MOTORCYCLE SERVICE DEPARTMENT

GL1200 ASPENCADE/INTERSTATE 1984 49 STATE MODELS 1985 CALIFORNIA MODELS LOW SPEED DRIVEABILITY IMPROVEMENT

(over) MTB 8860 (8506)

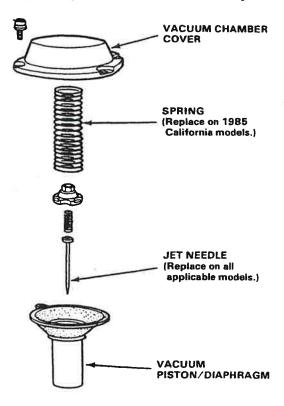
7. Install a new jet needle in each vacuum piston.

The new jet needles in the driveability kits are marked 1CS. This will help identify GL1200s that have been modified.
